THE REGIONAL MUNICIPALITY OF YORK

ADDENDUM # 1

BID # RTFC-1339-23-C23002

FOR: Renovation Projects Including Office Space, Corridor, and Washroom Renovations, known as Package D, at the York Region Administrative Centre, Located at 17250 Yonge Street in the Town of Newmarket

Question 10:

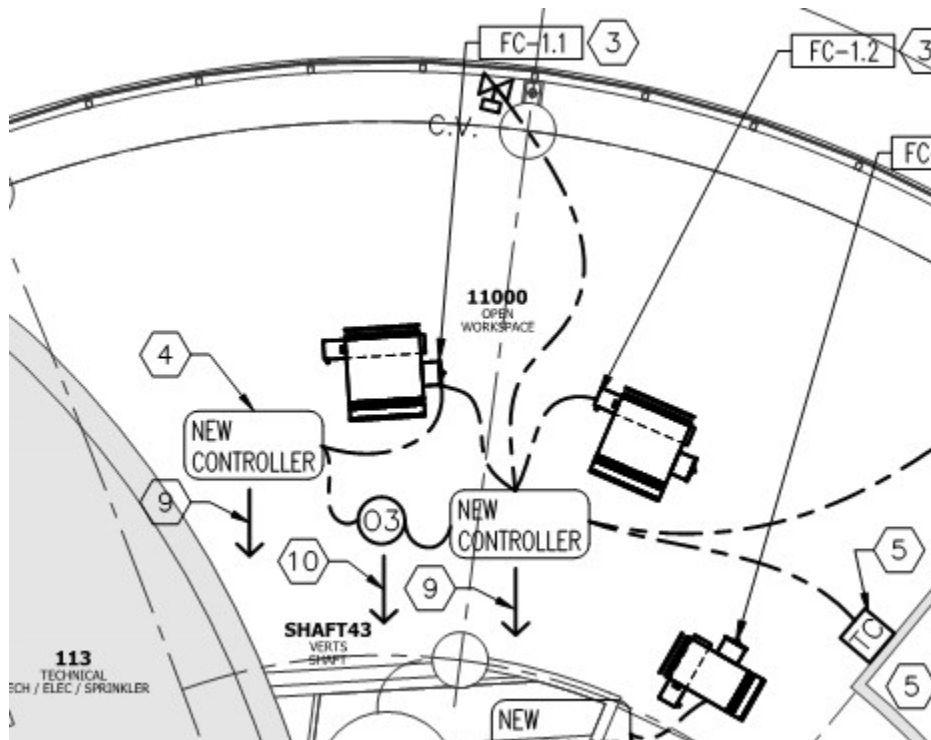
In regards to the BAS. Does the O3 controller require an Ethernet drop? Drawing M500 indicates that it is required. But the mechanical detail does not show it this way.

Yes, the 03 controller requires an Ethernet drop and shall be homerun back to the BAS control panel as indicated on the M-500 series.
